**Panoche Energy Center
06-AFC-5C**

**Petition to Amend
Final Commission Decision**

**Submitted to:
California Energy Commission**

**Submitted by:
PANOCHÉ ENERGY CENTER, LLC**

PROJECT SITE PLAN			
PANOCHÉ ENERGY CENTER			
FIREBAUGH, CA			
By: KF	Date: 9/17/2014	Project No. 32710176	
		Figure	3.4-1

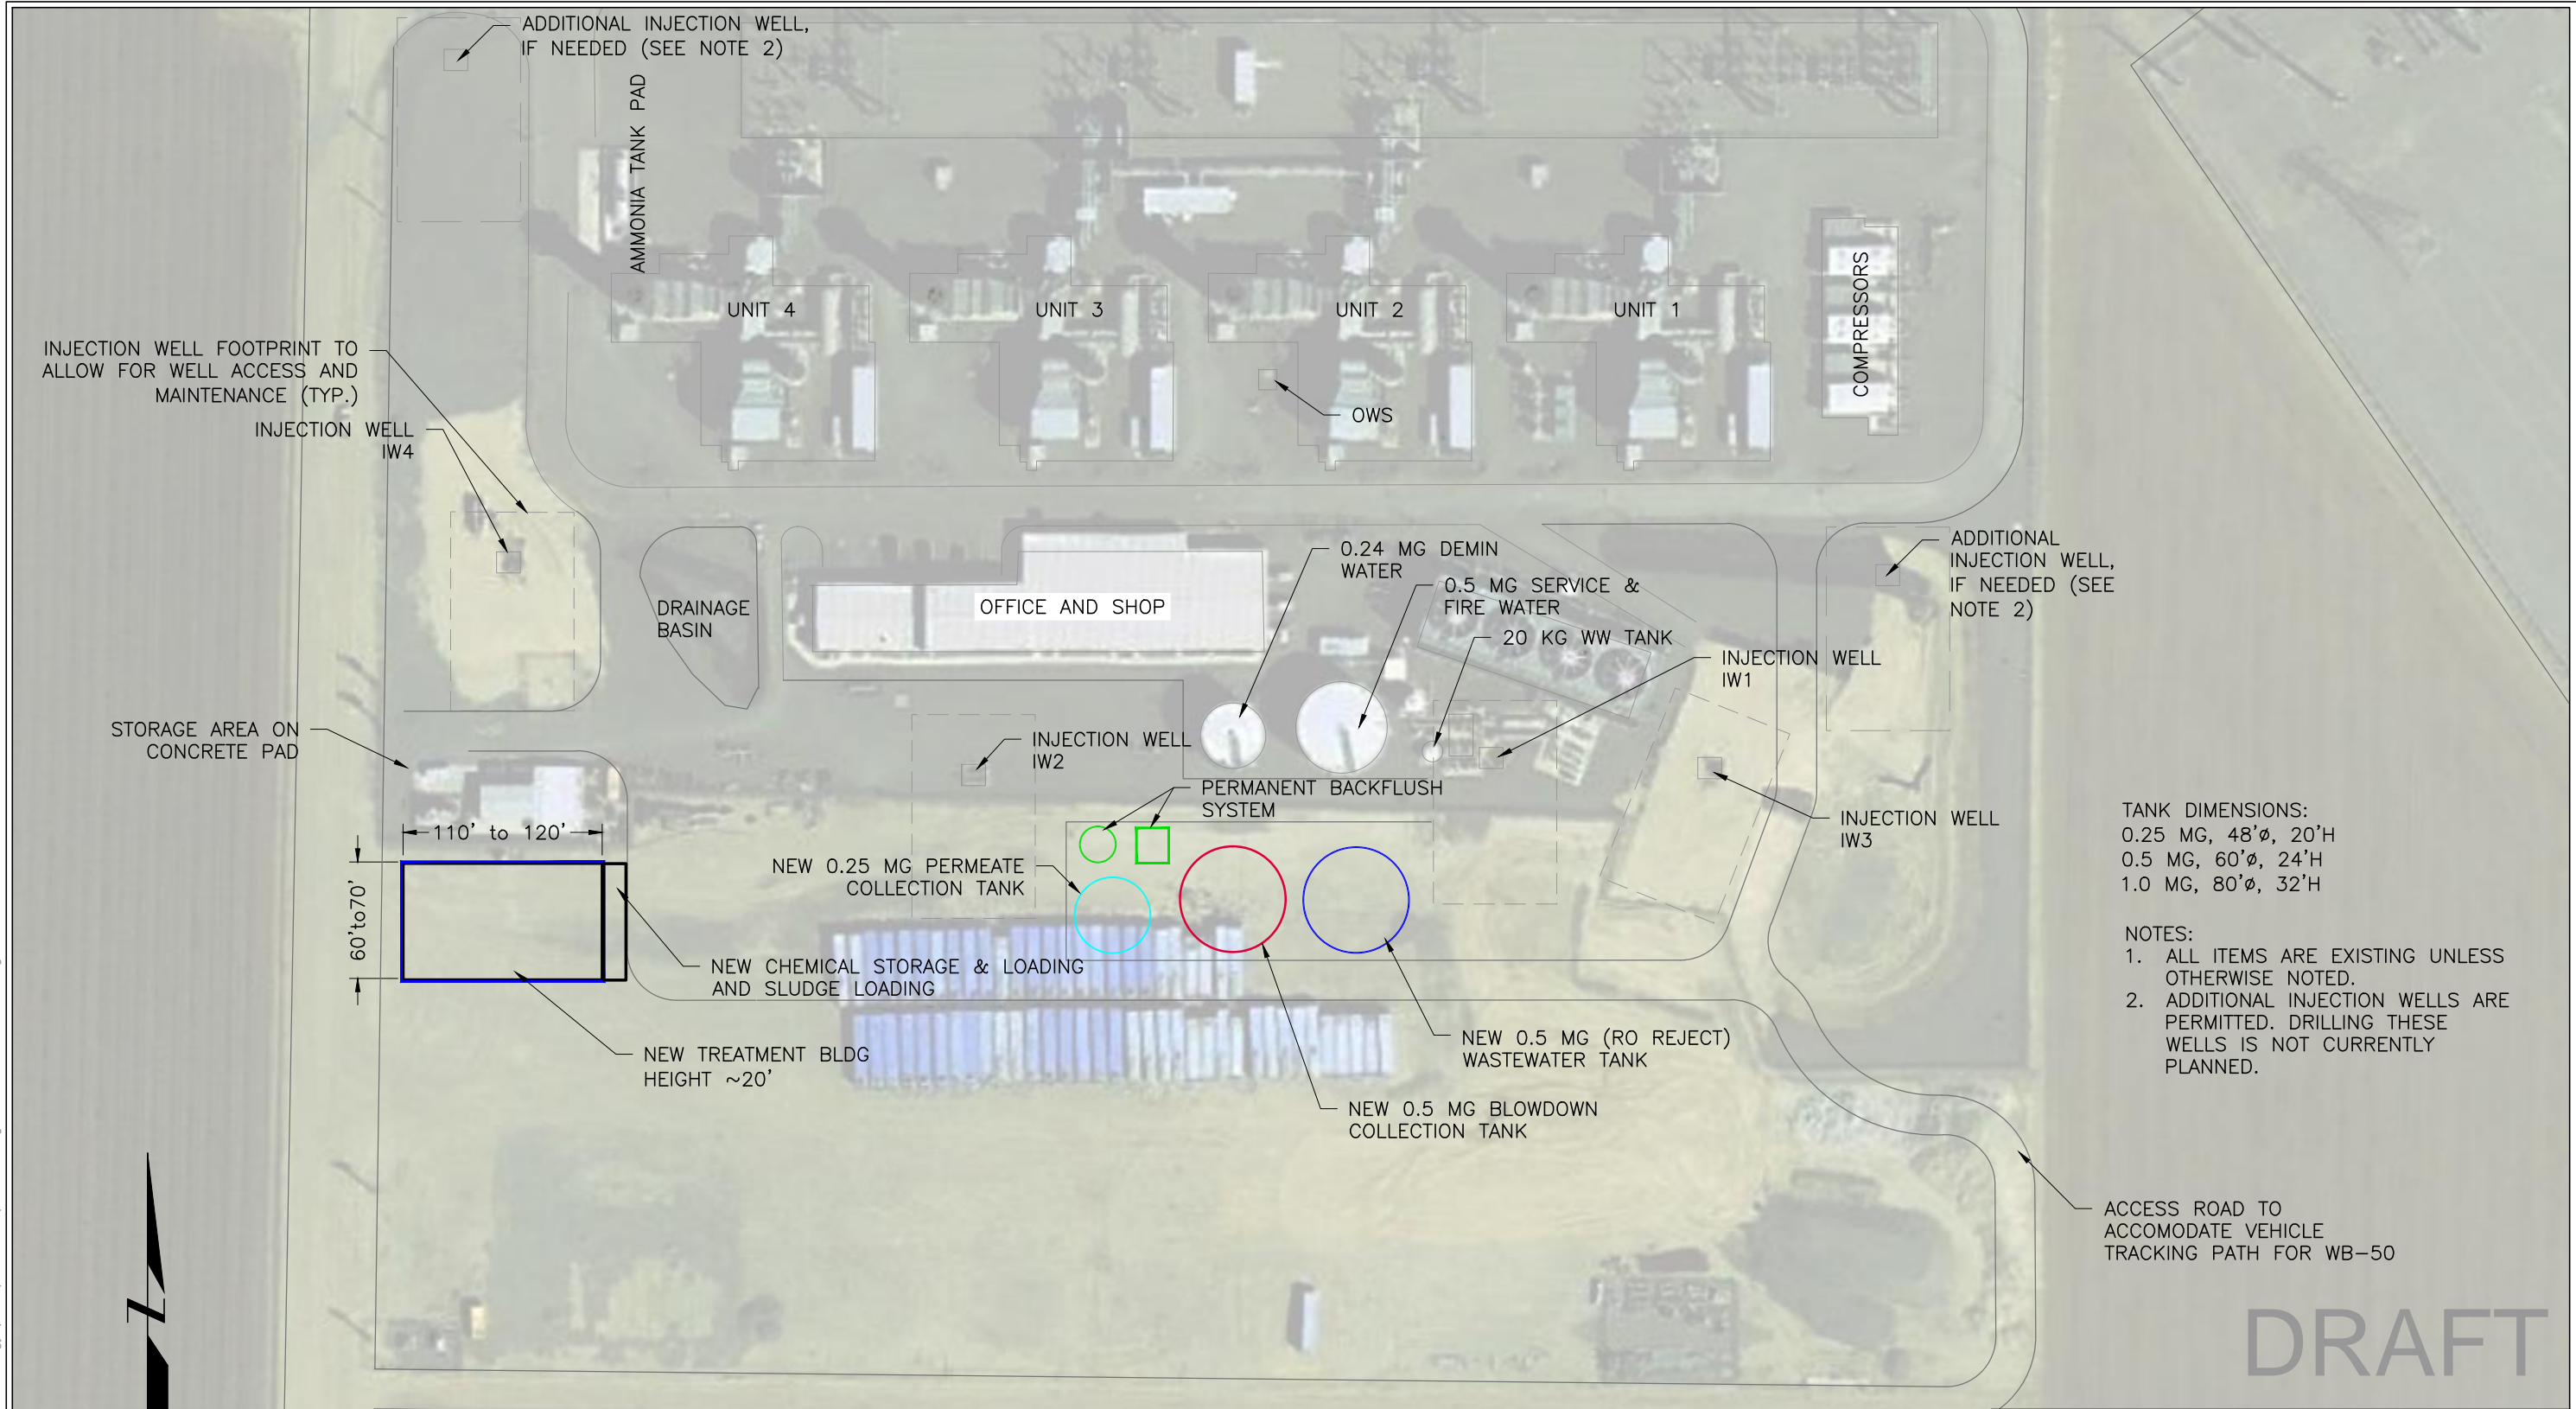
PEC is proposing the installation of an Enhanced Wastewater System consisting of up to three storage tanks, a permanent stand-by treatment system, and associated ancillary equipment. The proposed changes will be situated on a portion of the same 22-acre parcel as the existing PEC facility, and would be located adjacent to and south of the existing plant footprint on the former laydown area, as previously discussed. During construction of the PEC the laydown area was previously disturbed and cleared of vegetation. This Petition involves expanding the permanent PEC site to include a 3.5-acre portion of the former laydown area for the proposed changes, i.e. adding three storage tanks, permanent stand-by wastewater treatment system, and associated ancillary equipment, as presented on Figure 3.4-1, *Project Site Plan*.

The site layout showing the proposed changes is presented on Figure 3.4-1, *Project Site Plan*. Implementation of the changes discussed in this Petition will be situated on 3.5 acres of the former laydown area within the PEC parcel, and would be located adjacent to and directly south of the PEC project. The 12.82-acre previously approved PEC project site will be modified to add a 3.5-acre portion of the former laydown area.

By: KF	Date: 9/17/2014	Project No. 32710176	
		Figure 5.5-3

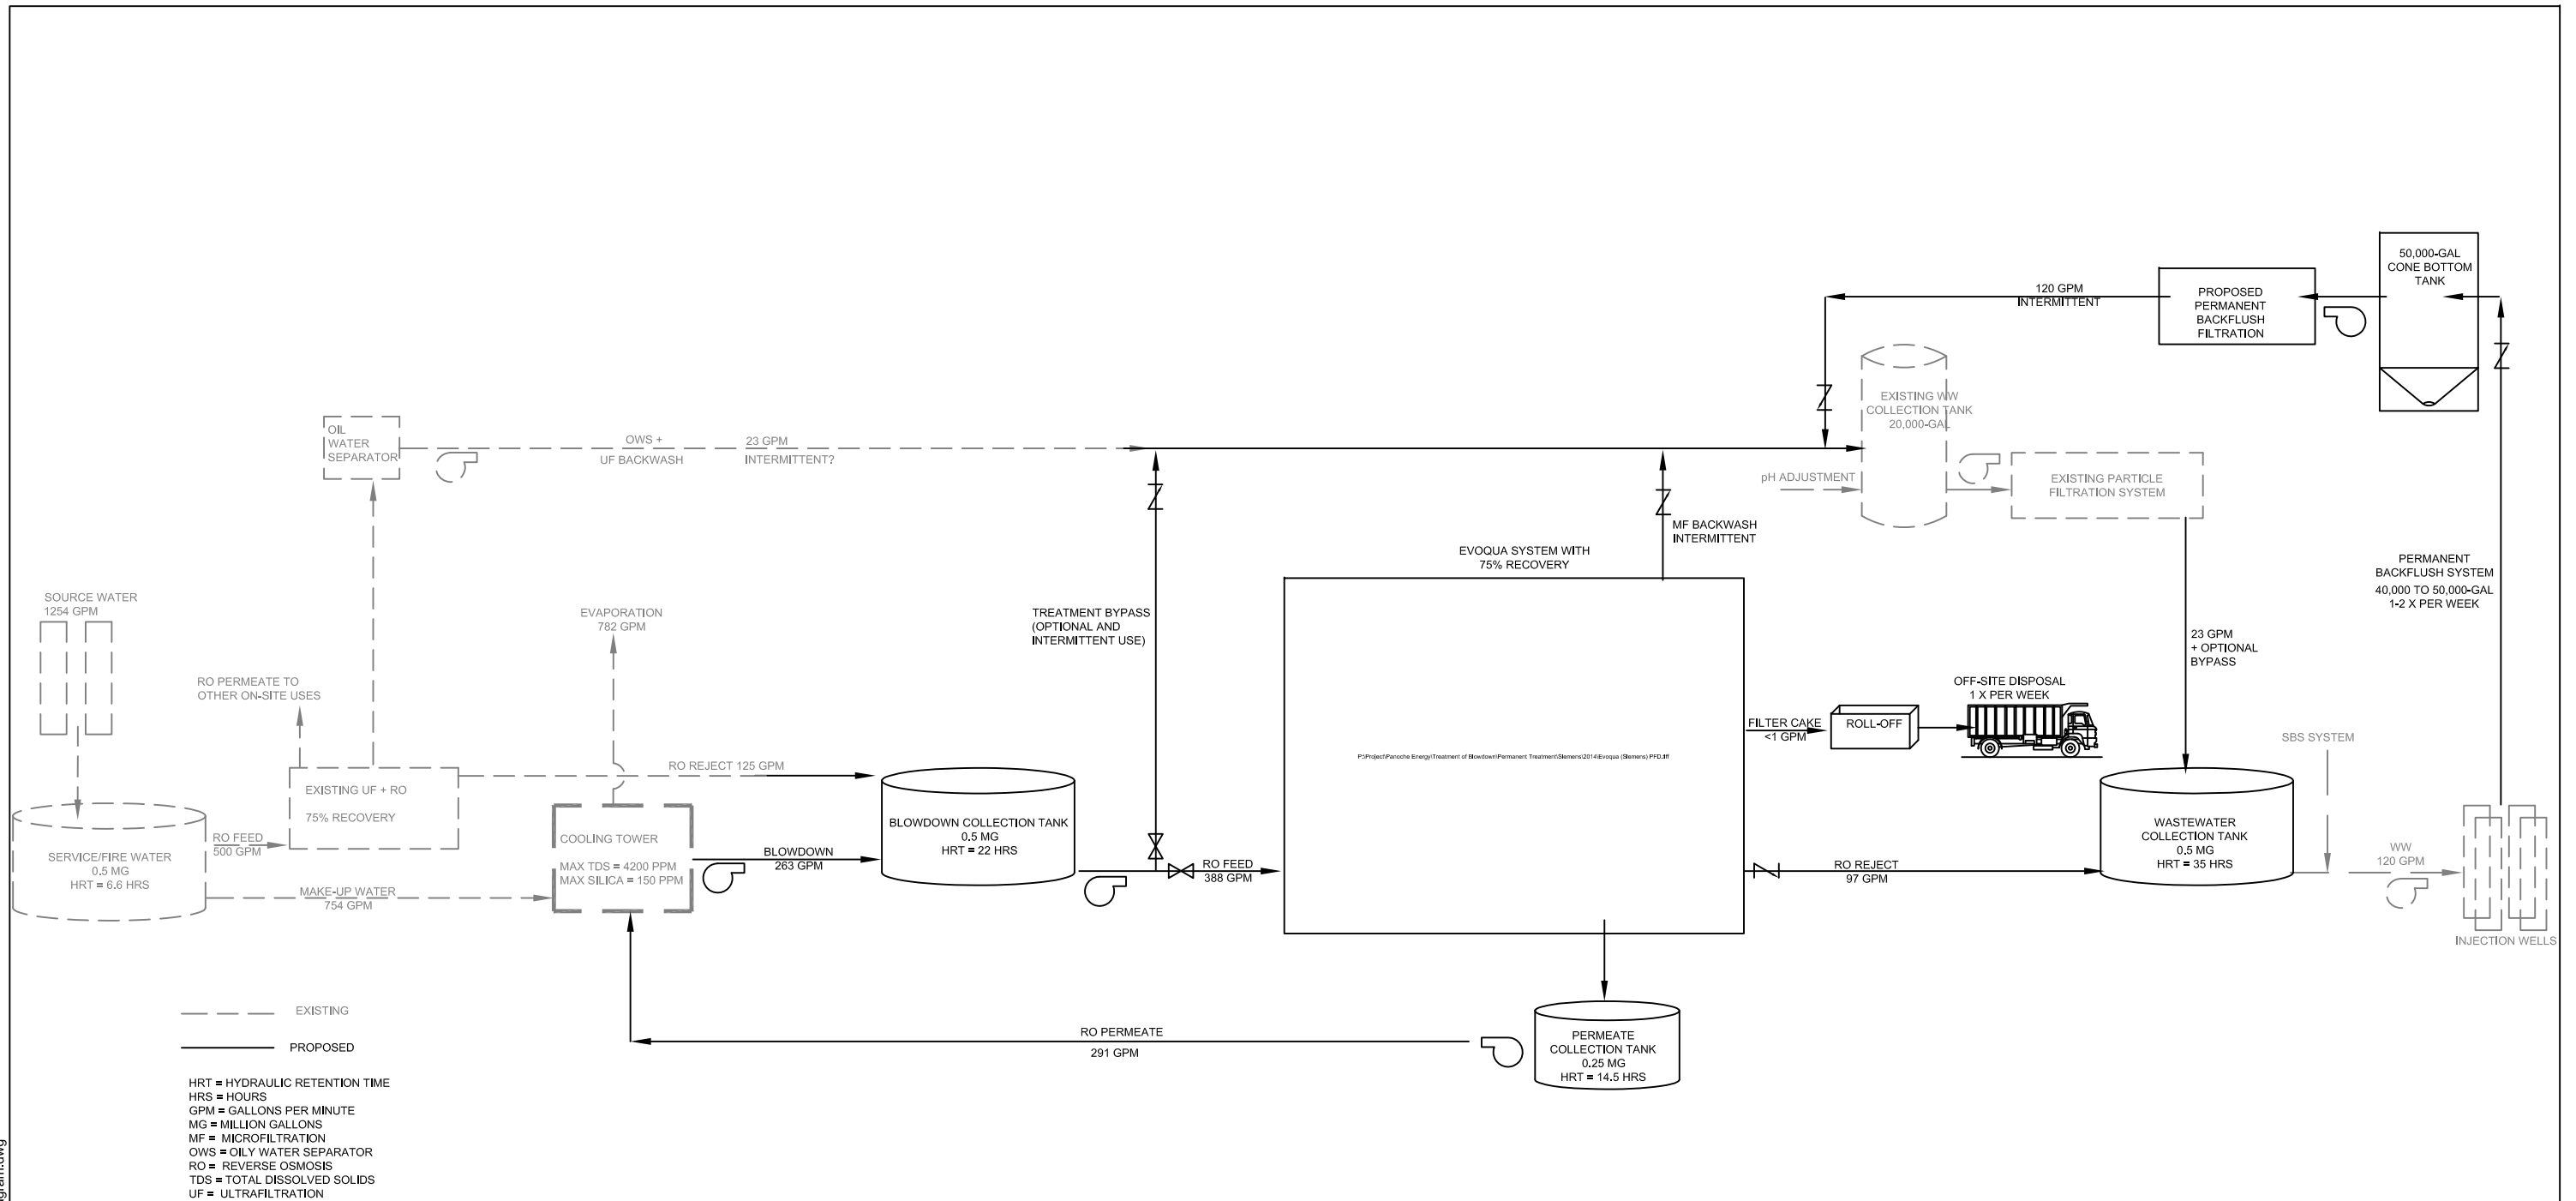
5.5.3.2.2 Project Wastewater Streams. Wastewater from the cooling tower will enter a treatment system and the treated water will be returned to the cooling tower. The reject water from the cooling tower will be sent to the injection wells. Recycling cooling tower water and increasing the number of cycles in the cooling tower will reduce the demand for pumped groundwater and will reduce the volume of wastewater sent to the injection wells. Refer to Figure 5.5-3 *Water Balance Flow Diagram*.
